PRODUCT CHANGE NOTIFICATION

TISP® THYRISTOR SURGE PROTECTORS

Bourns Announces Changes to Select TISP® Thyristor Surge Protector Products

TSP1904

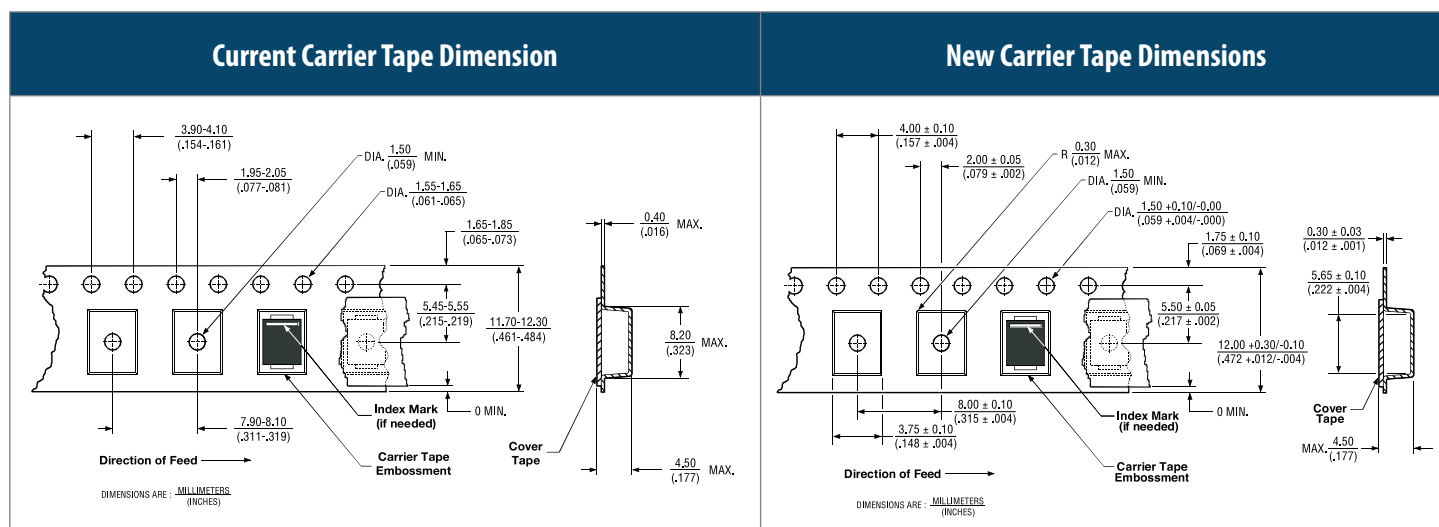
Riverside, California – May 31, 2019 – In the spirit of continuous improvement, effective November 1, 2019, Bourns is changing (i) the mold compound on the SMB (DO-214AA) package to EK3600GH, (ii) the leadframe design and material to C19210, and (iii) the dimensions of the carrier tape for select TISP® Thyristor Surge Protector Products. There is no change to the data sheet rating or electrical characteristics of the products.

These changes have no impact on the form, fit, function, quality or reliability of the affected products. The product marking and label will remain unchanged. The changes to materials, mold compound, leadframe design and material will impact the process for producing the affected parts. The carrier tape dimension changes will affect the fit and form of the packaging as shown.
